Per the incomplete letter dated January 21, 2025:

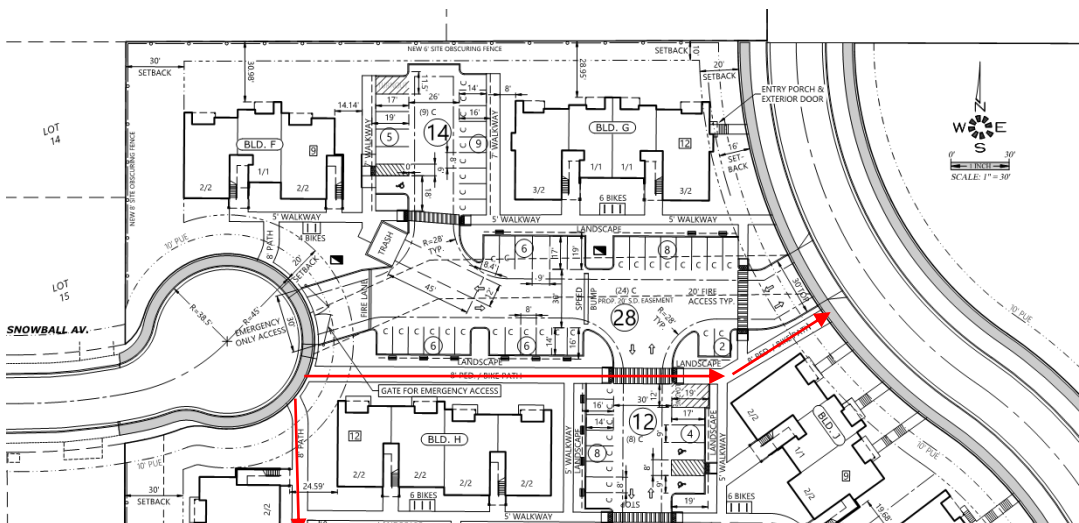
***Site Safety (Retaining Wall):** Finished floor is 4 feet above the top of the retaining wall as shown on Sheet SDR 6.

Therefore, the height of the retaining wall will not obstruct visibility.
